To: **Hampshire County Council**
From: **Iceni Projects**
Date: **January 2017**
Title: **Langstone Gate, Havant – Construction of coffee unit**

1. This Transport Note (TN) has been prepared by Iceni Projects on behalf of Seaward Properties to address the comments provided by Hampshire County Council (HCC) on the Transport Assessment (TA) for the above site, submitted in October 2016. Specifically this TN is intended to provide a response to each of the points outlined in the letter from Holly Drury dated 29th November 2016.
2. The majority of the headings used within the HCC have been maintained for ease of reference within this TN.

Proposed Signal Junction Amendments

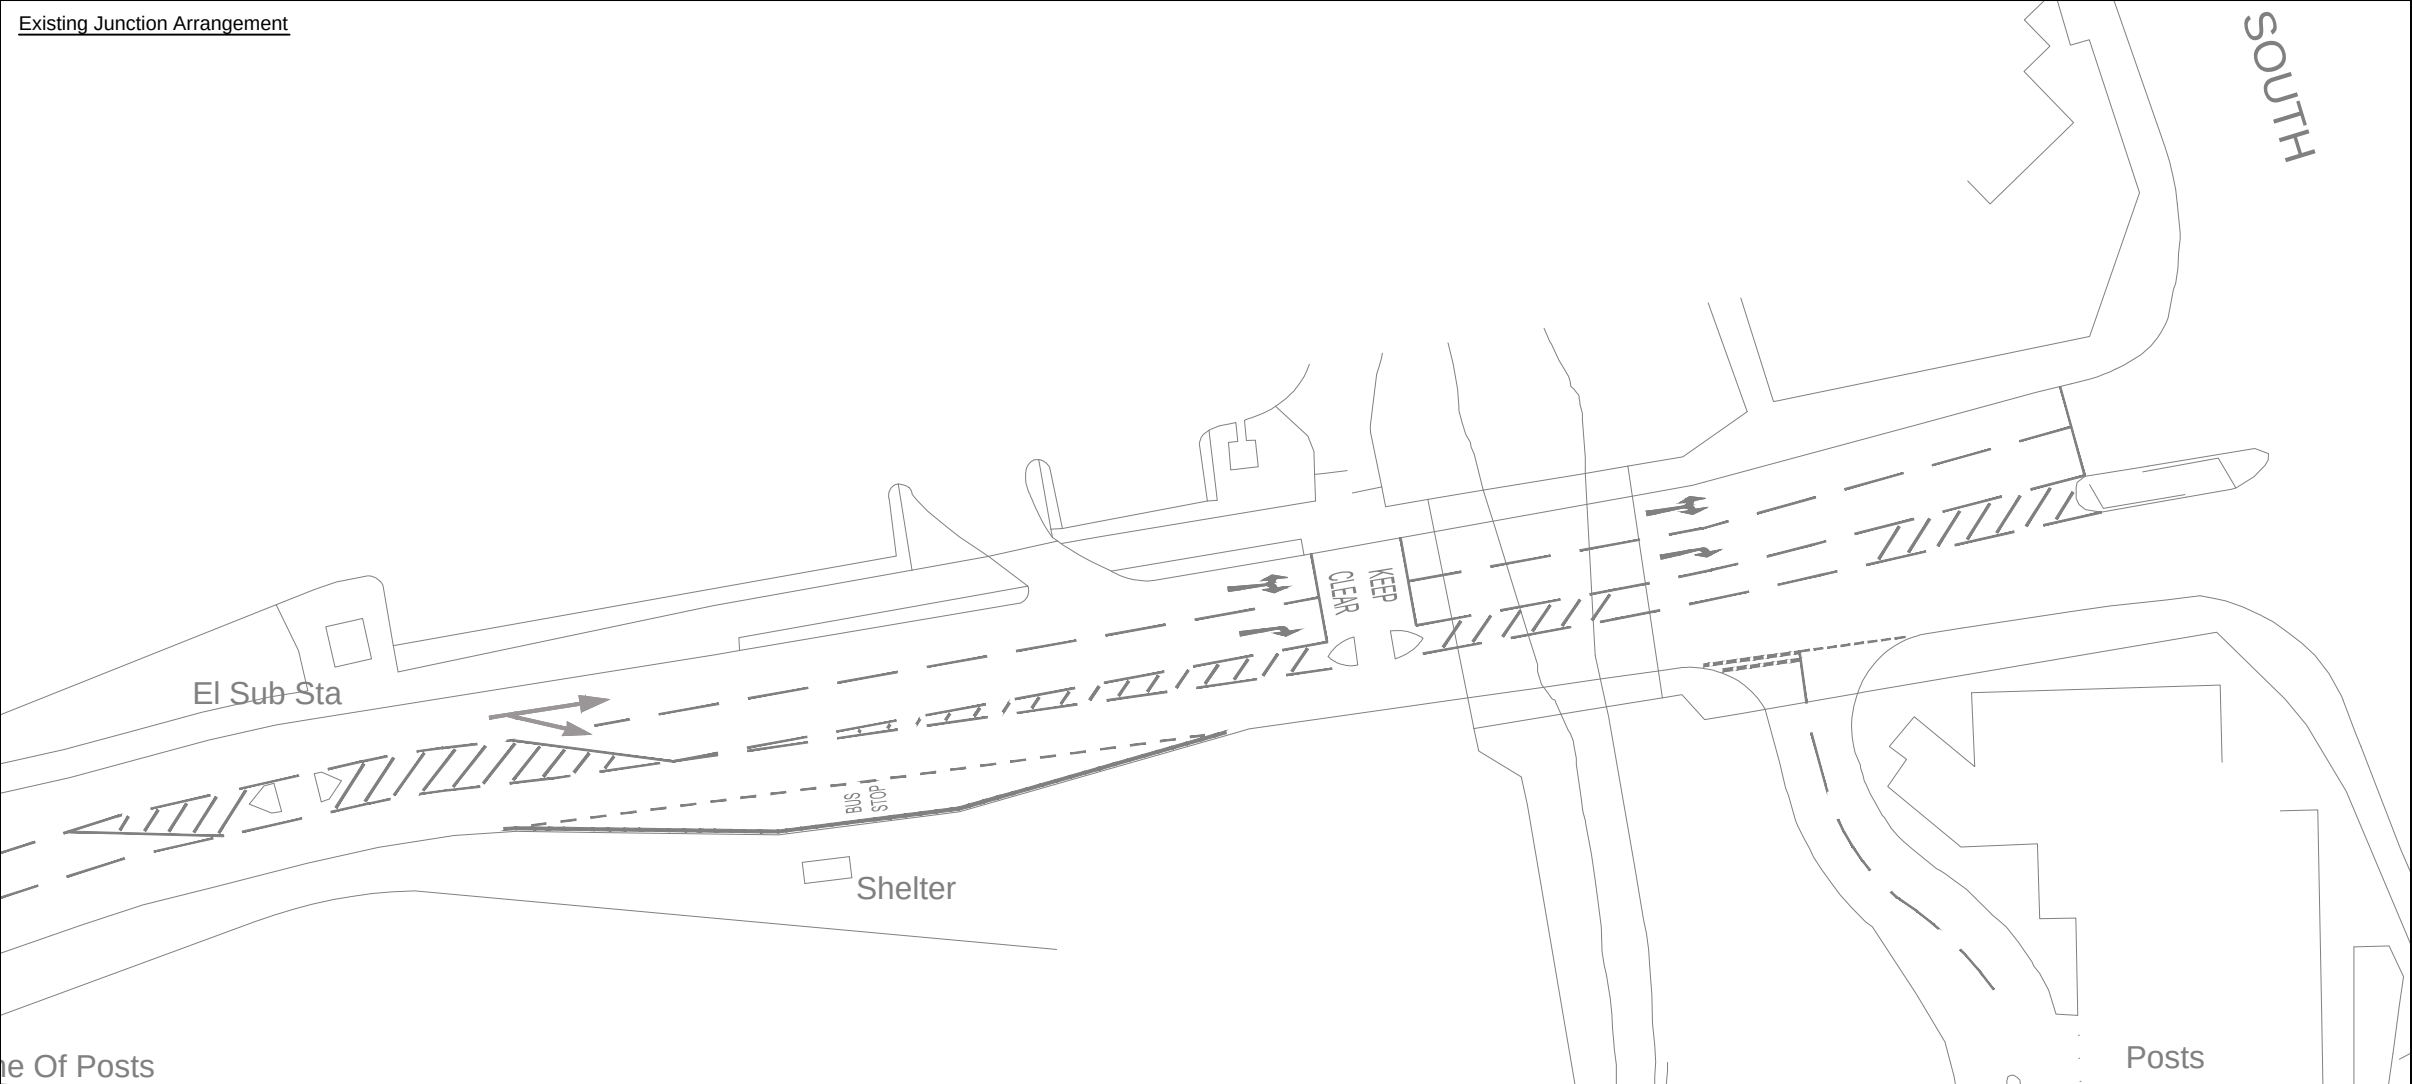
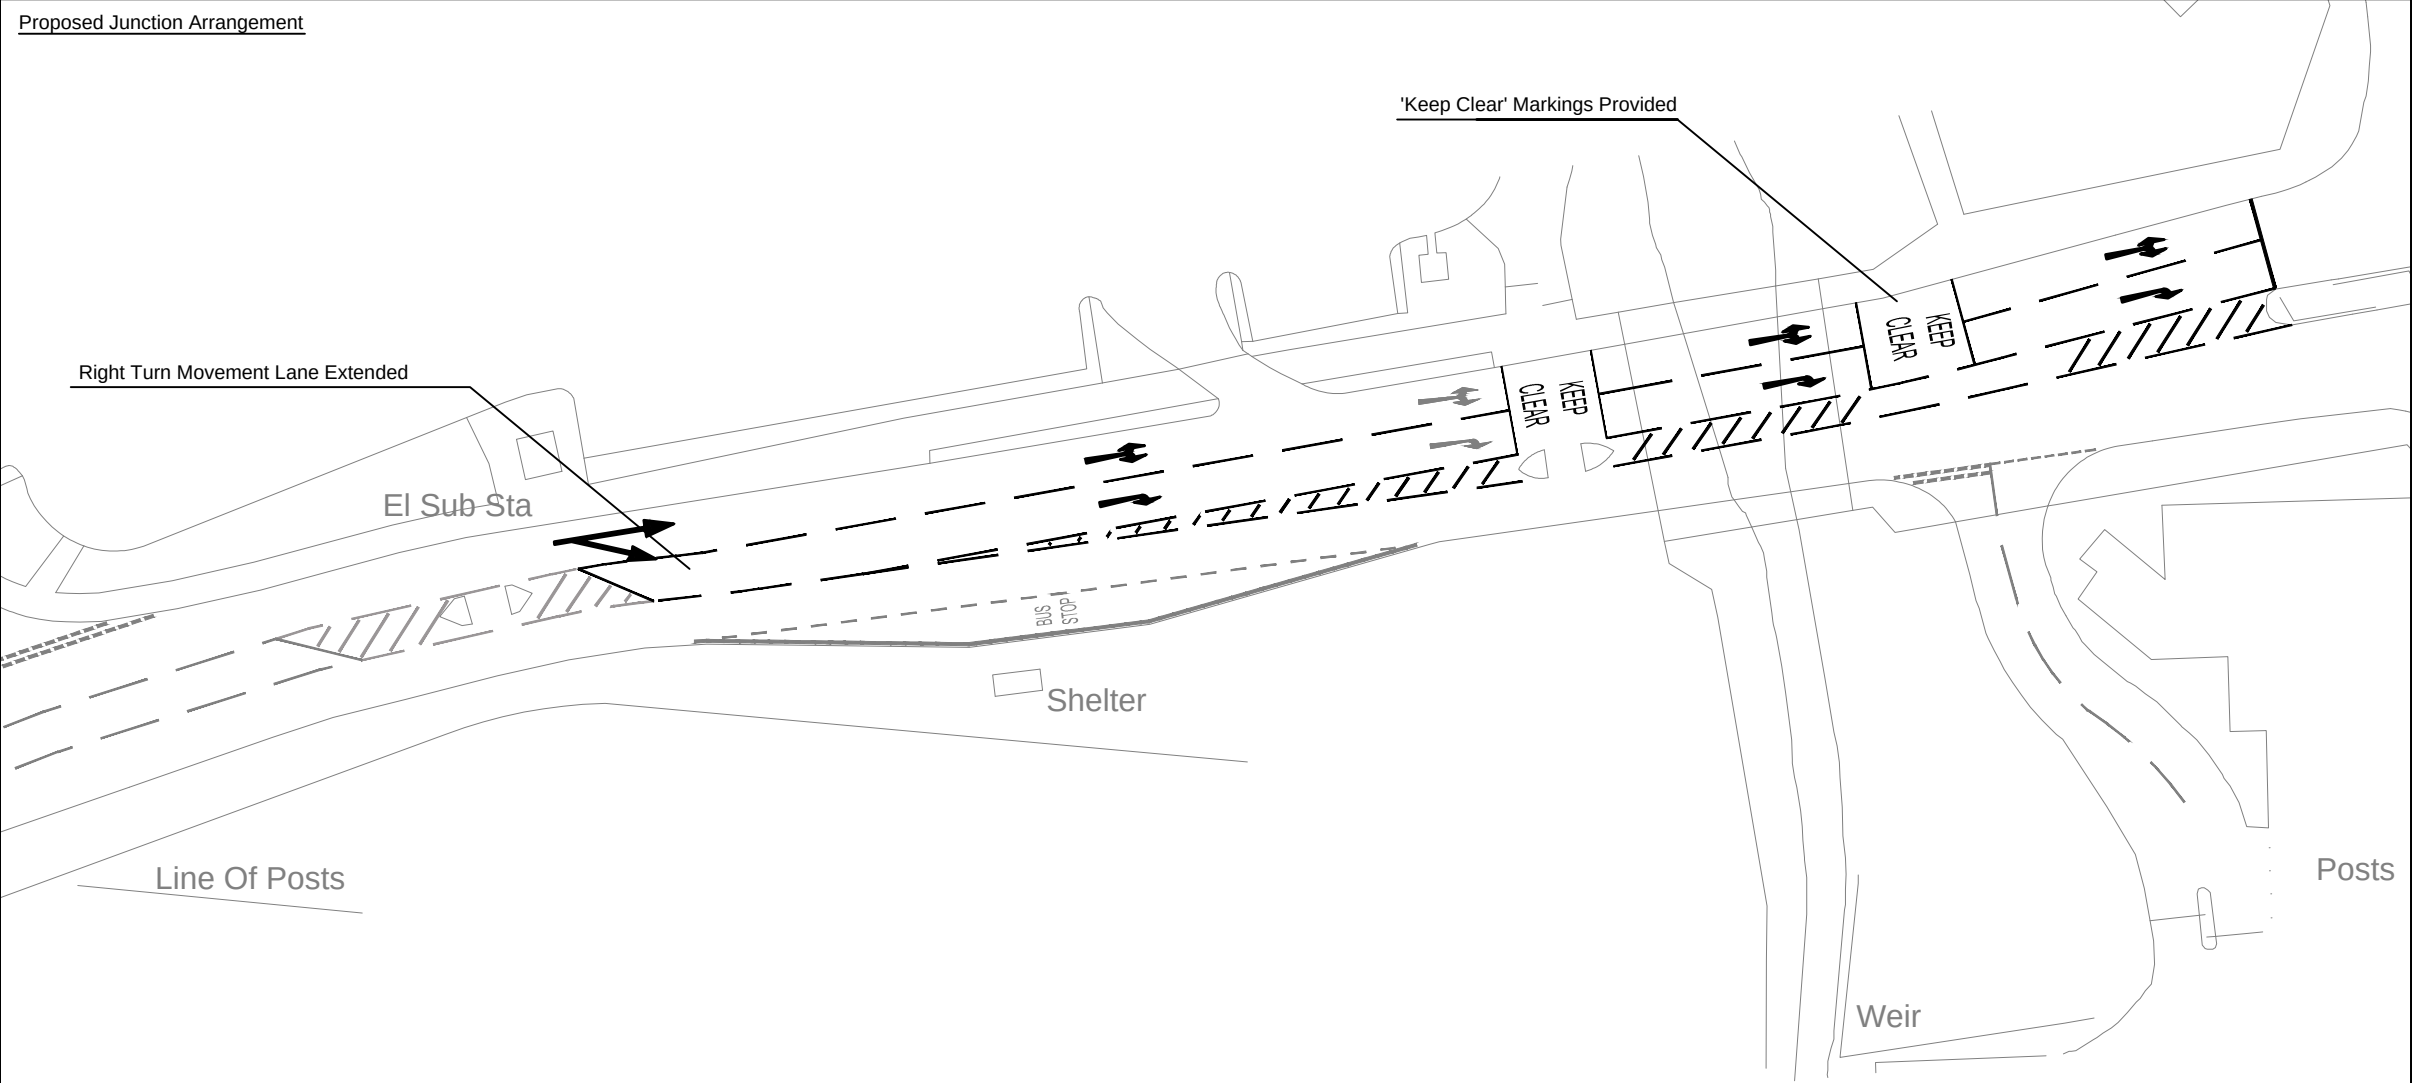
The HCC note raises concerns with the proximity of the existing site access junction and park Road/Solent Road junction. These concerns relate specifically to the perceived difficulty for vehicles turning right out of the site access towards the junction when there are instances of queuing on the Solent Road approach, and the associated safety risk this would entail.

In response to this, Icení has proposed modifications to the Solent Road approach to improve both the existing situation at the junction, and mitigate any potential impact which the development proposals would have on its operation. It is proposed to introduce 'Keep Clear' markings opposite the proposed site entrance to ensure that vehicles could exit the existing site access and join Solent Road on the approach to the junction without the potential to block vehicles travelling west on Solent Road. In conjunction with this it is also intended to modify the approach to the junction on Solent Road to extend the two-lane approach to the junction so that any impact of the proposed modifications on the capacity of the junction would be negligible. The 'Keep Clear' marking would represent a loss of stacking space on the junction approach of 14m (2 x 7m lanes) and would be replaced by 14m of additional right turn lane at the junction, meaning no net loss in stacking space at the junction.

The proposed improvement scheme is shown on drawing **16-T084_03** appended to this note.

12. As stated earlier in this note, Icení has proposed modifications to the Solent Road approach to improve both the existing situation at the junction, and mitigate any potential impact which the development proposals would have on its operation. It is proposed to introduce 'Keep Clear' markings opposite the proposed site entrance to ensure that vehicles could exit the existing site access and join Solent Road on the approach to the junction without the potential to block

vehicles travelling west on Solent Road. In conjunction with this it is also intended to modify the approach to the junction on Solent Road to extend the two-lane approach to the junction so that any impact of the proposed modifications on the capacity of the junction would be negligible.

13. These proposals are shown in drawing 16-T084_03, and the junction has been remodelled to assess any impact these proposals will have. The associated impact of the proposed development in the 2021 base is shown to be 4.2% (increase in DoS) from 94% to 98.2%). The increase in associated maximum queuing continues to be shown as 3 vehicles. It is considered that there is minimal increase in DoS compared to the previous assessment and as such, the proposed junction amendments will have little impact on the its operation. The associated increase in maximum queue length is also considered well within usual daily traffic variations and falls well short of being considered to represent a severe impact.

Existing Refuse Swept Path Analysis

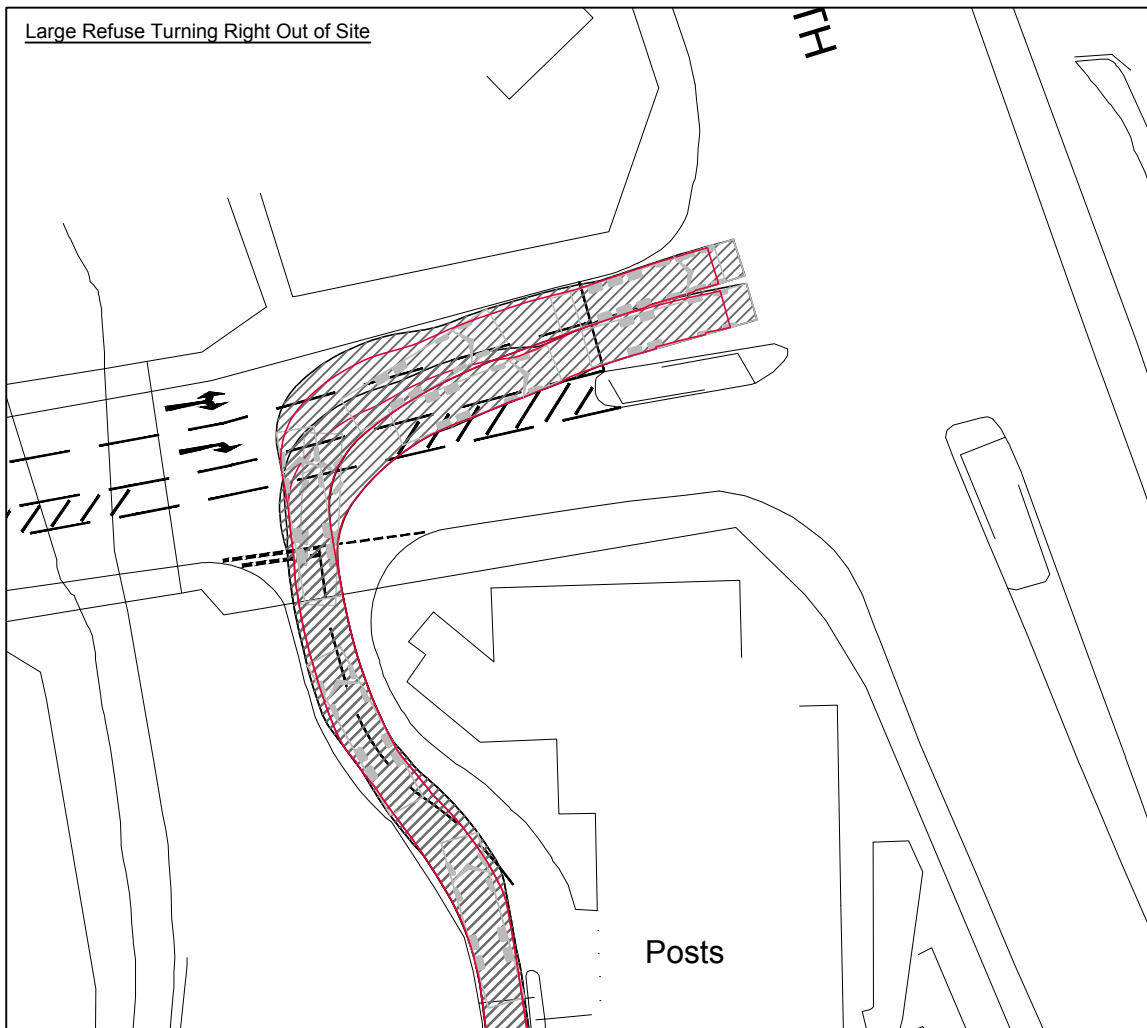
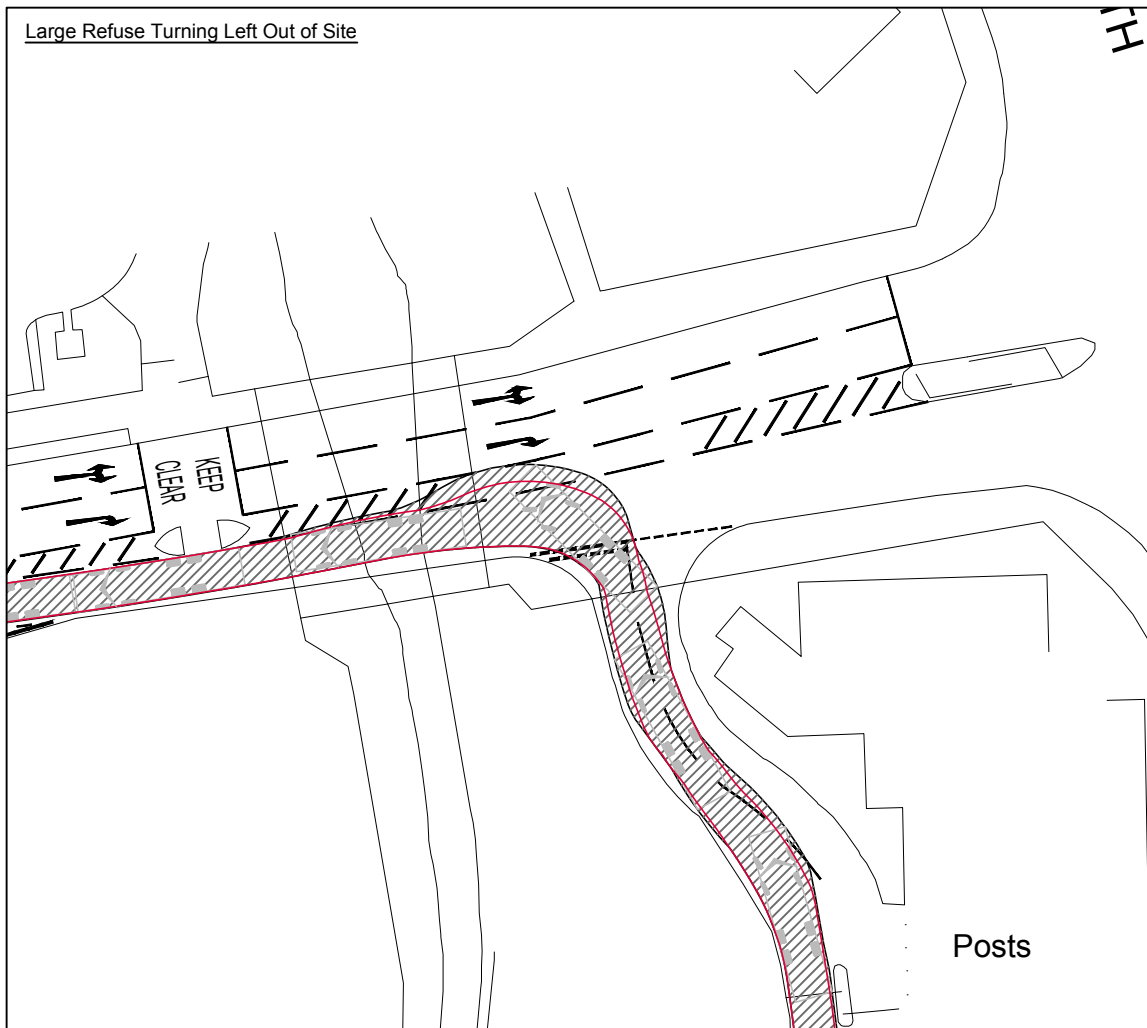
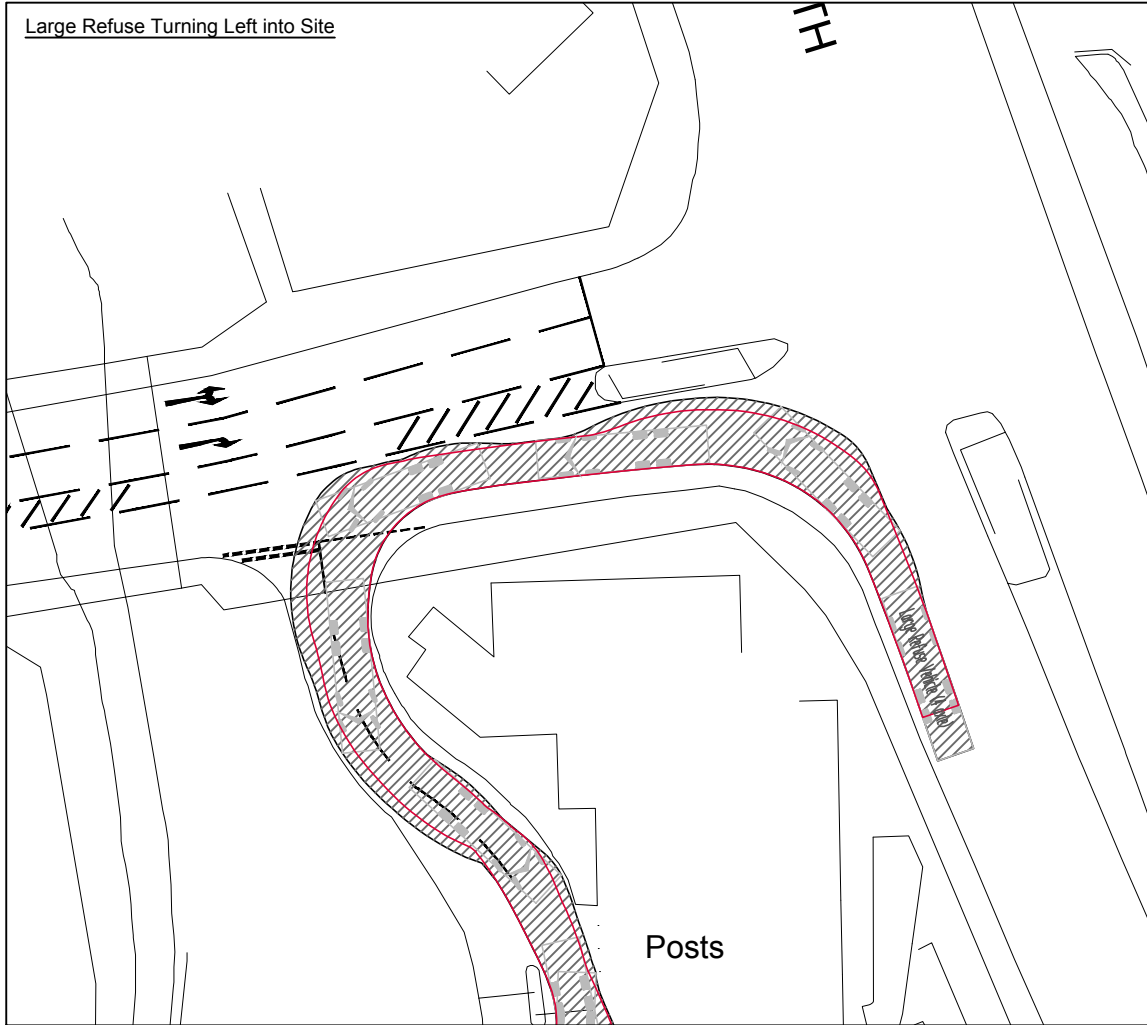
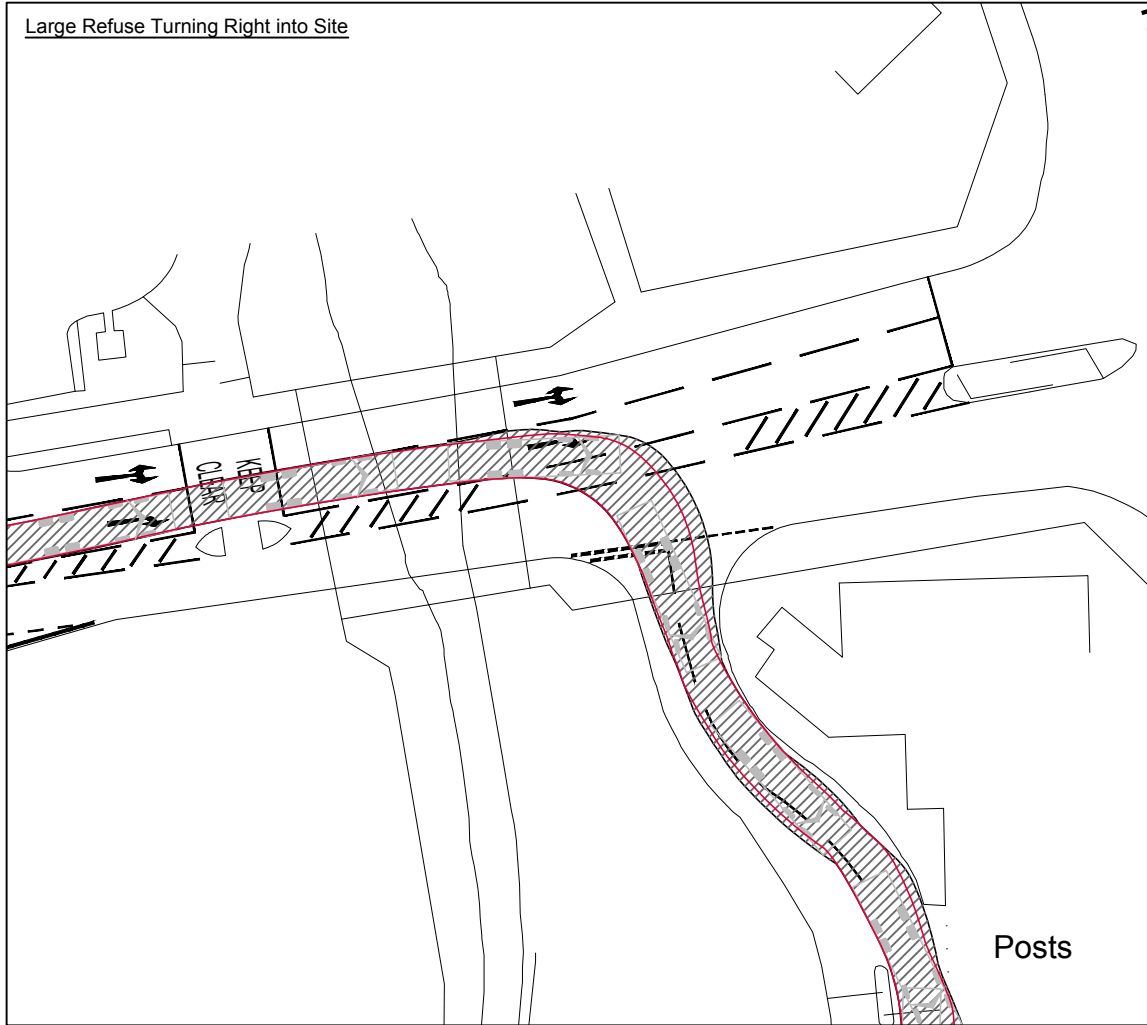
5. The details of the site access were incorrectly provided within the application submission. It is not intended to include any modifications to the existing car park access as previously shown. The existing access currently accommodates HGV movements associated with servicing and deliveries to the existing office use of the site. As such it is expected that any servicing and delivery movements to the proposed Starbucks use could be accommodated by the existing junction. It could also be conditioned as part of any planning permission that servicing and deliveries be restricted to outside of peak hours.

Swept path analysis of the existing site access junction has been undertaken and is shown on drawing **16-T084_04** appended to this note.

- The existing site access arrangements will remain unchanged and are considered fit for purpose to serve the proposed development. This is demonstrated by the swept path analysis.
